DART AEROSPACE LTD	Work Order: 100942
Description: Crosstube High Aft (205/212)	Part Number: D212-664-201
Inspection Dwg: D212-664-241 Rev: D	Page 1 of 1

DRAWING NO. D212-664-241	TITLE CROSSTUBE ASSY (205/212 HI AFT)	REV. D	DART AEROSPACE LTD ENGINEERING ORDER		D.E.O. NO. D212-664-241-D-1	SHEET NO. SHEET 1 OF 2	SCALE NTS
DRAWN	CHECKED		MFG. APPR.		APPROVED	DE APPR.	
DATE 11.04.07	DATE 11.04.11		DATE 11.04.12		DATE 11/04/12	DATE 11.04.12

DRAWING NO. D212-664-241	TITLE CROSSTUBE ASS'Y (205/212 HI AFT)	REV. D	DART AEROSPACE LTD ENGINEERING ORDER		D.E.O. NO. D212-664-241-D-2	SHEET NO. SHEET 1 OF 1	SCALE NTS
DRAWN 9	CHECKED ASS	MFG. APPR. 8	APPROVED MAD		DE APPR. H		
DATE 11.07.15	DATE 11.07.20	DATE 11.07.21	DATE 11.07.21		DATE 11.07.21

D212-664-241/-241B
ASSEMBLY DETAIL

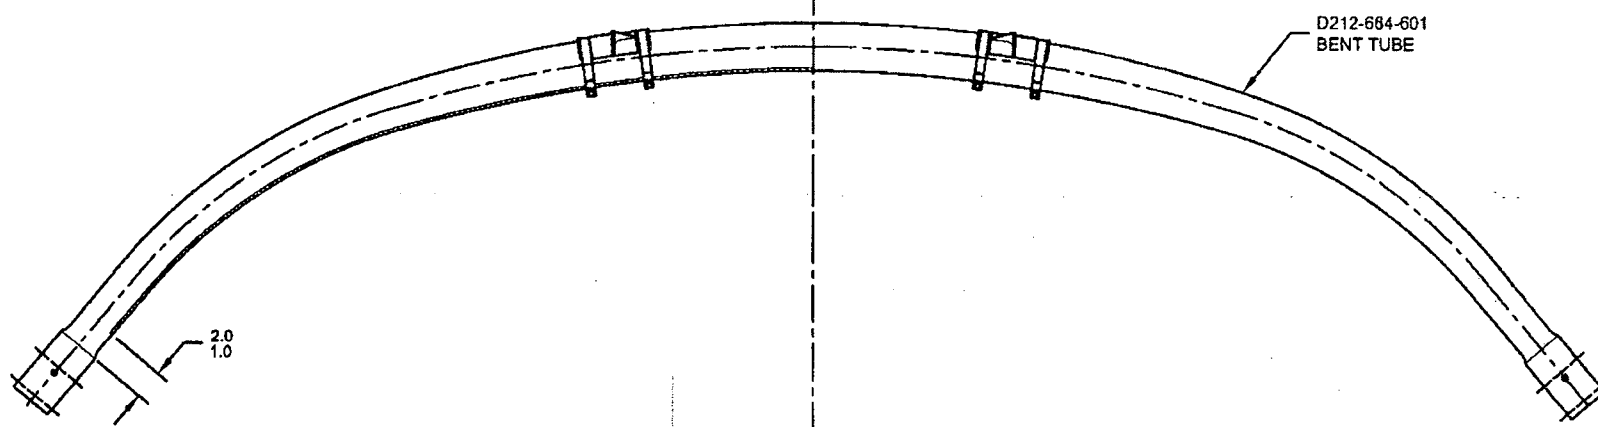
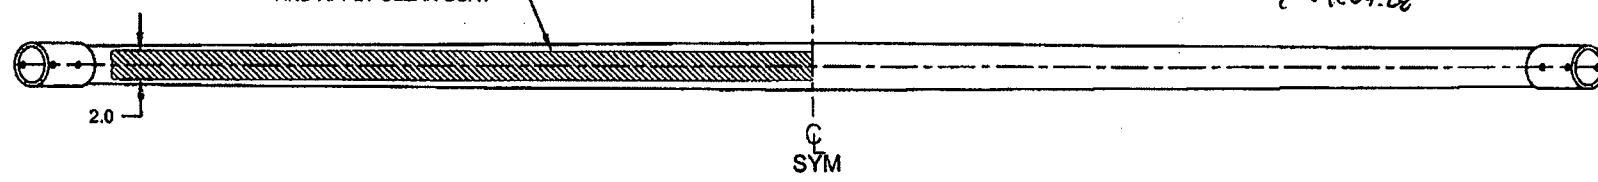
ADD AN INSPECTION WINDOW TO UNDERSIDE OF CROSSTUBE.

NOTES 2 OF SHEET 1 IS AMENDED AS FOLLOWS:

MASK AREA PRIOR TO PAINTING,
REMOVE MASKING AFTER PAINT
AND APPLY CLEAR COAT

- 2) FINISH: CHEMICAL CONVERSION COAT PER DART QSI 005 4.1
PRIME INSIDE AND OUTSIDE PER DART QSI 005 4.2
MASK UNDERSIDE OF CROSSTUBE AS SHOWN (HATCHED AREA) AND
PAINT OUTSIDE PER DART QSI 005 4.2
REMOVE MASKING AND APPLY CLEAR COAT

FIGURE 1: SUPPORT INSTALLATION

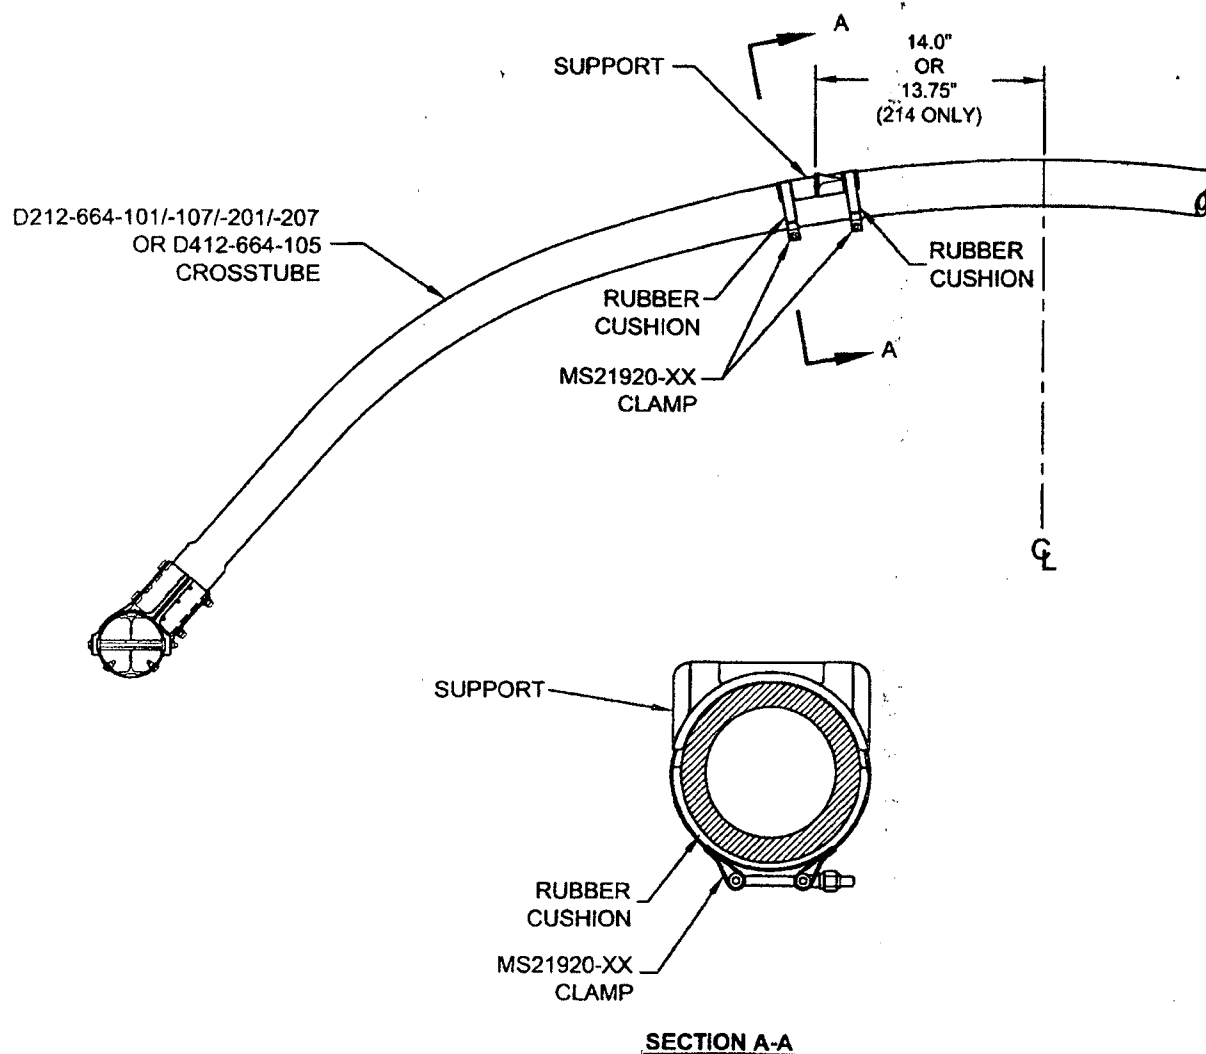
For the crosstubes listed above, section 32.4 of ICA-D212-664 is amended as follows. Use Figure 1 of this service instruction and Figures 32-2 to 32-9 of ICA-D212-664 for further reference. For crosstubes of an earlier change number, it is recommended that if the supports are removed, the supports should be reinstalled using the procedure listed below.

- 32.4.5 Apply a 0.04" to 0.07" thick layer of Proseal 890 Class B or AMS-S-8802 Class B sealant underneath applicable support and install support as shown in Figure 1 of this service instruction.

- 32.4.6 Install the clamps opposite to crosstube support as shown in section A-A of Figure 1. Install rubber cushions underneath each clamp around the bottom circumference of the crosstube up to the crosstube centerline. Torque clamps 80-100 in-lb (9.0-11.3 Nm). It is acceptable to use smaller or larger sized MS21920-XX clamps than those listed in ICA-D212-664, ensure that after torquing the clamps per this instruction, the nuts are in safety but not bottomed out
